ISSUE	DATE	AMENDMENT
01	25.06.10	For inclusion in Development Application
02	27.07.10	New elevations for inclusion in Development Application
03	15.10.10	Council request for additional information
04	28.01.11	Council request for additional information

DEVELOPMENT APPLICATION
New Independent Living Units
Lourdes Village
95 Stanhope Road, Killara
For Aevum Limited

DWG NO
DA.00

TITLE
Southwest - Basement + Roof Plan

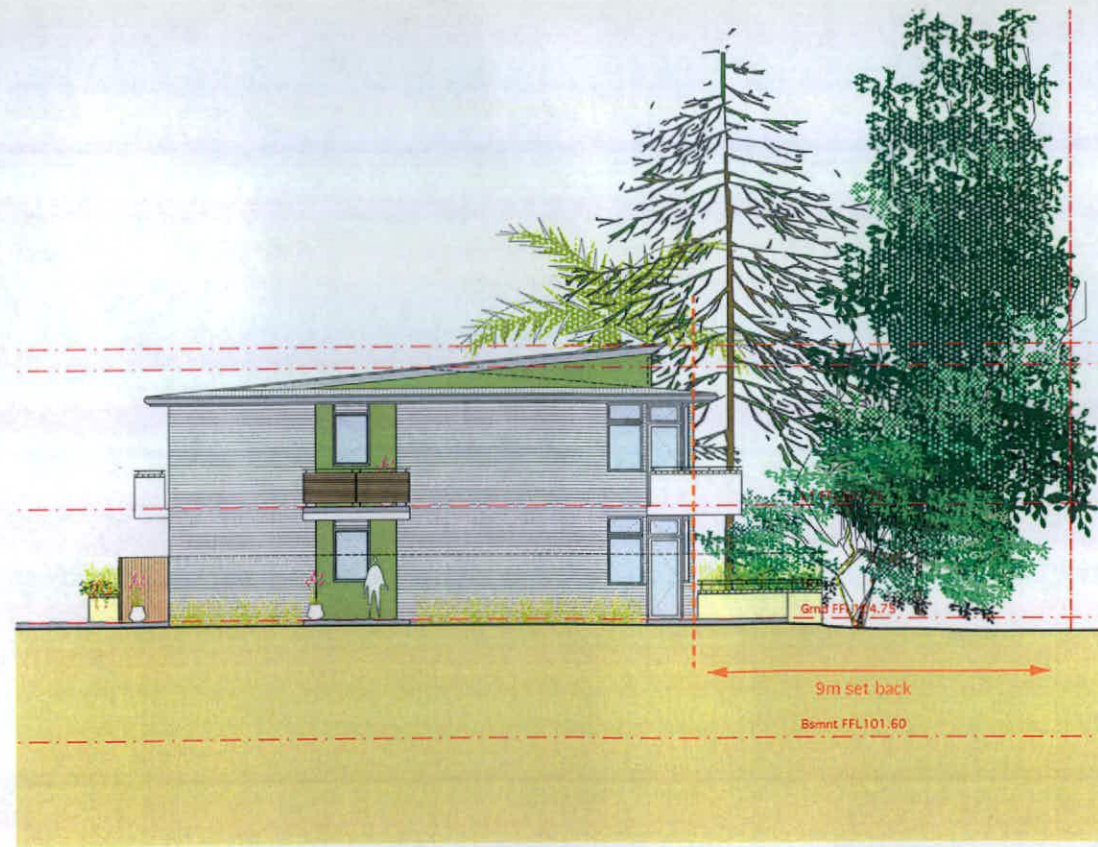
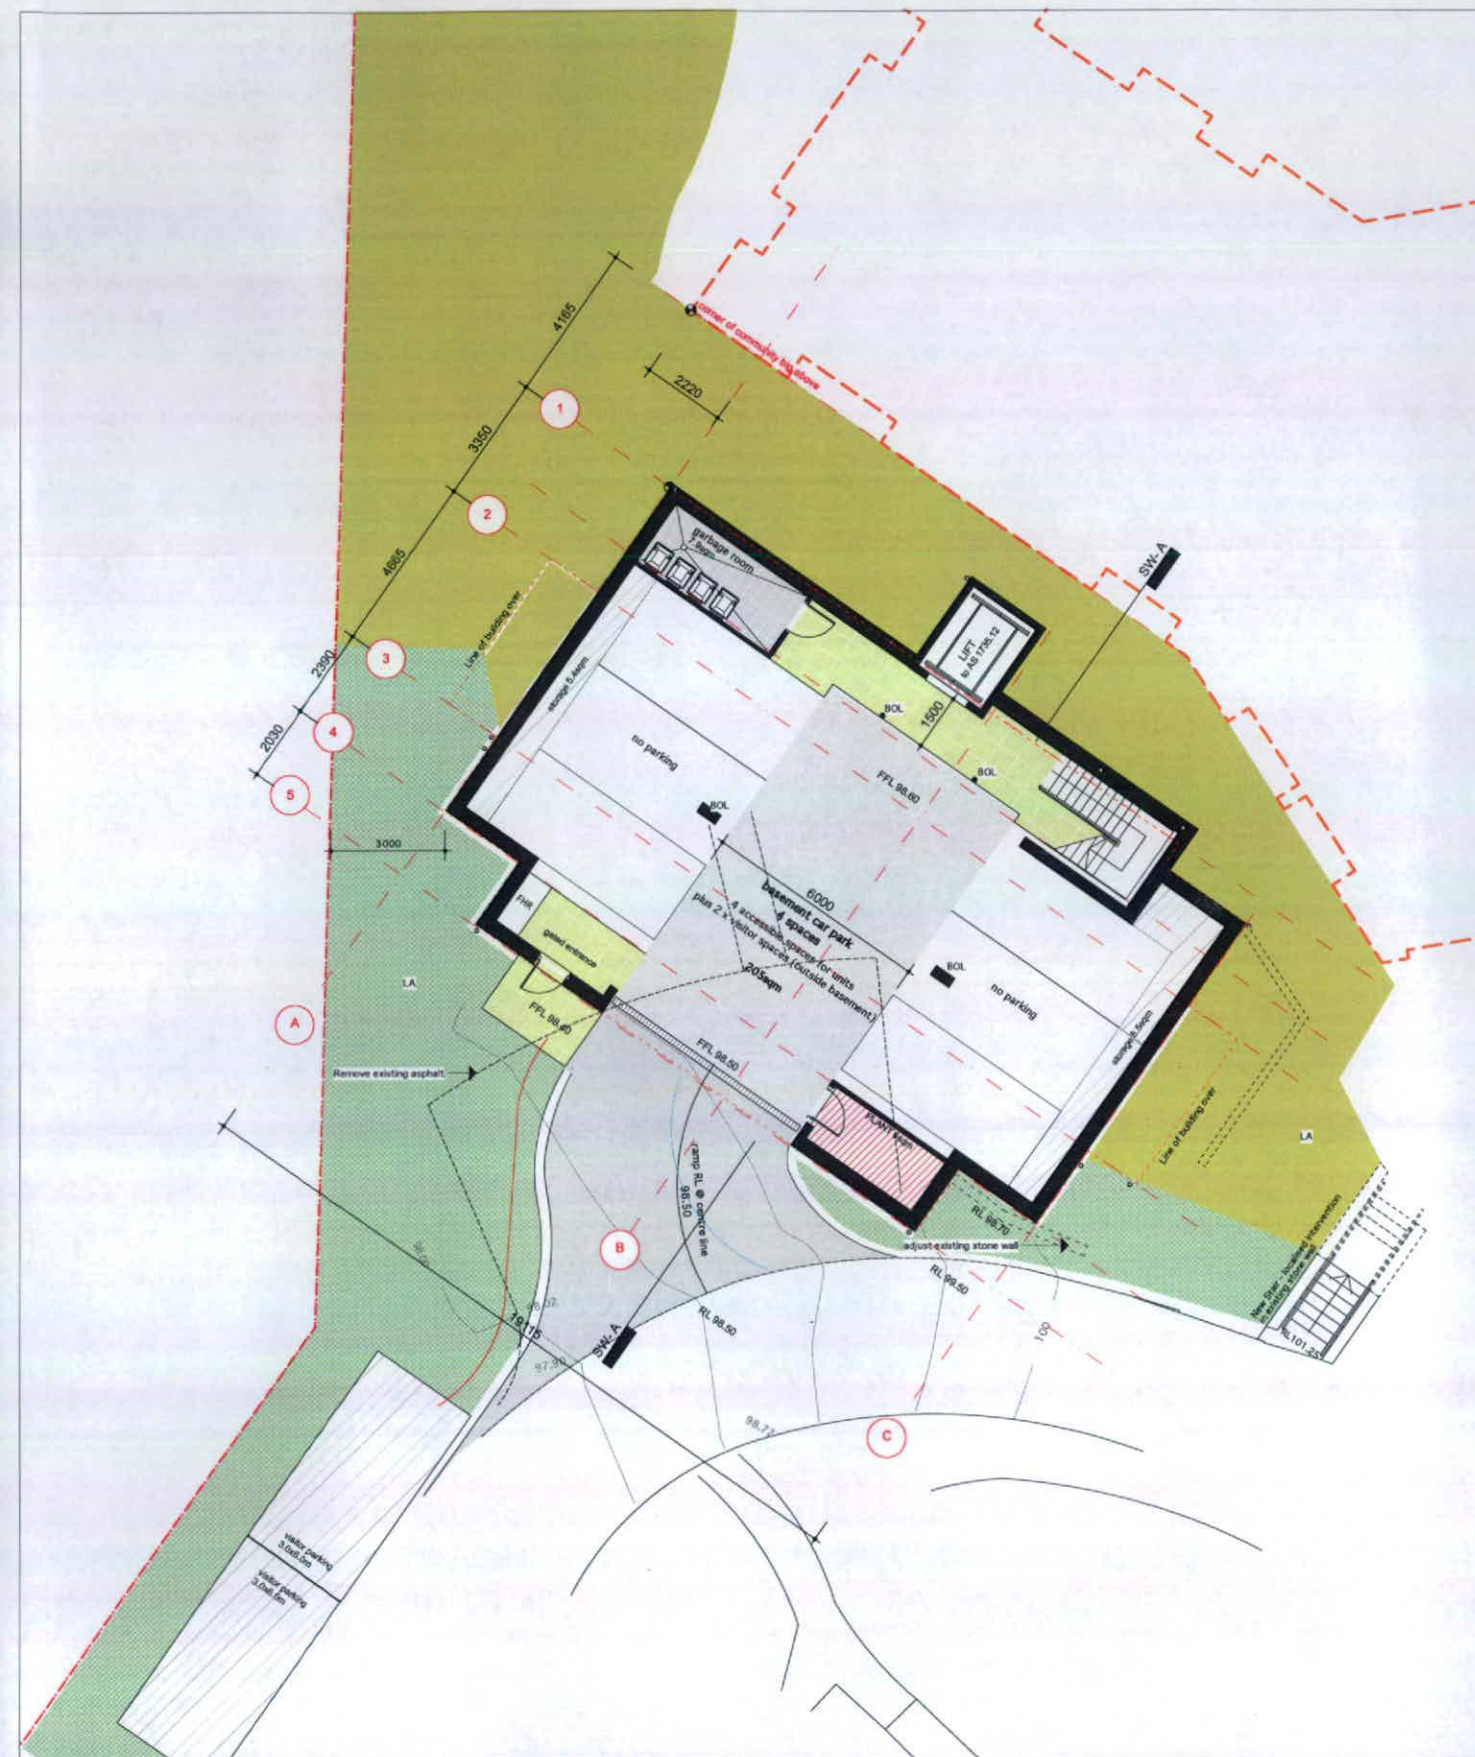
RECEIVED
18 OCT 2010
Amendments
1. Balconies extended

TITLE	ISSUE	SCALE	DATE	DRAWN	CHECKED
Southwest - Ground Plan	B	1:100 @ A1		JKCK/KH	PT

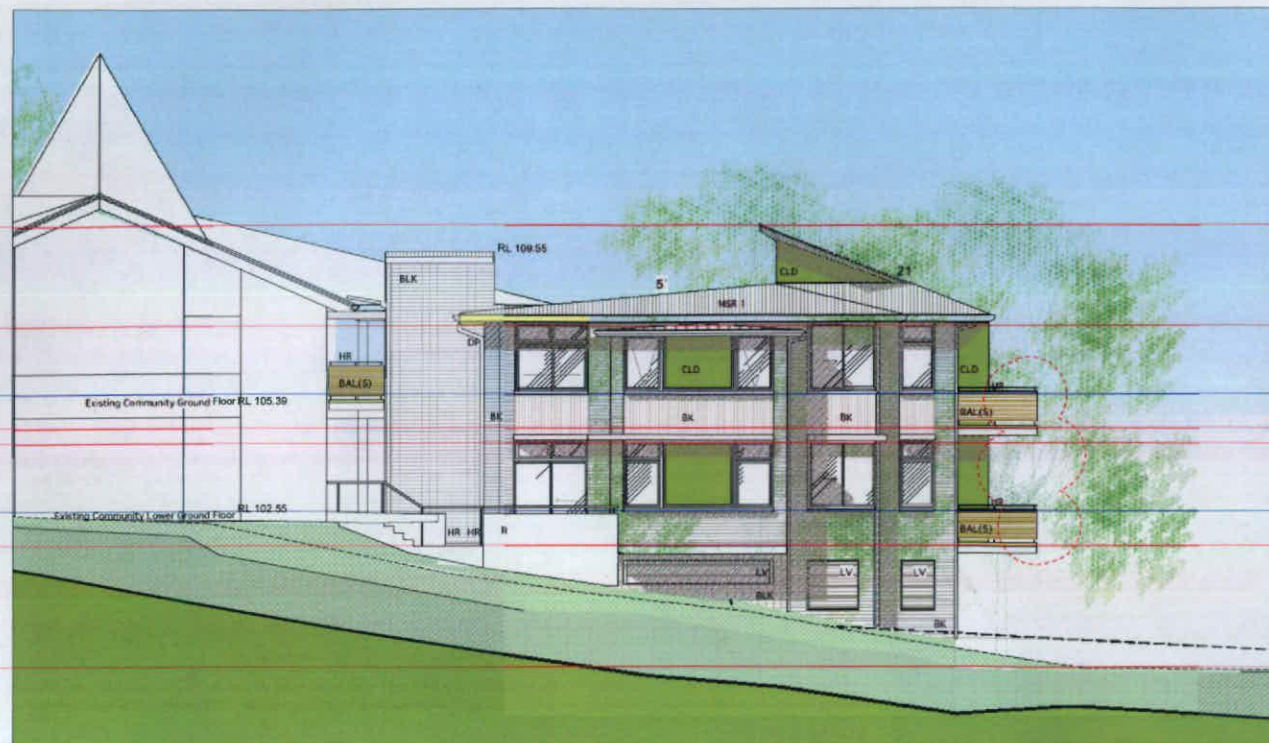
- Amendments
1. Balconies extended
 2. Lockable letter boxes added
 3. Entrance door accessible compliant
 4. Kitchen has a wall oven added
 5. laundries moved to allow entrance door to move
 6. Acoustic compliance note added.
